ТО	Robin Berry – Donna Horn
JOB NAME	CP0096 Mesa Burn Facility Expansion
DELIVERY	FTP Site Upload
RFI#	21
FROM	JE Bowen Construction
DATE	07-18-2016

Request: Connections at Column Line C-5

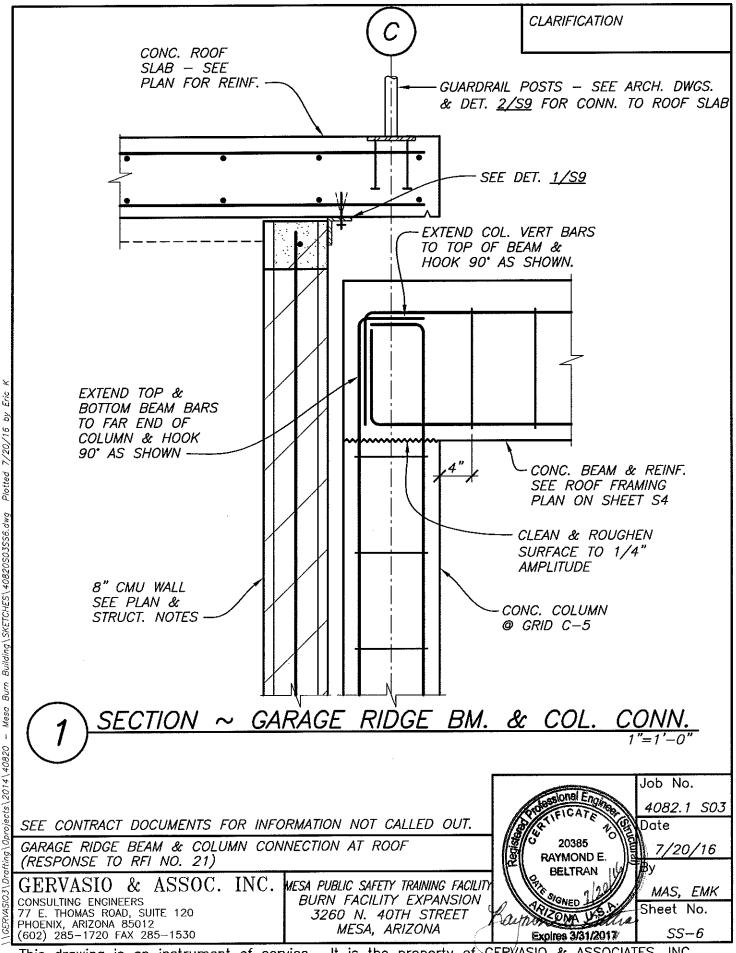
At column C-5 beam RB-1 connects in for the "garage" roof and the column continues up for connections at the roof of the main building, we cannot locate any details showing how these connections will happen.

Please advise.
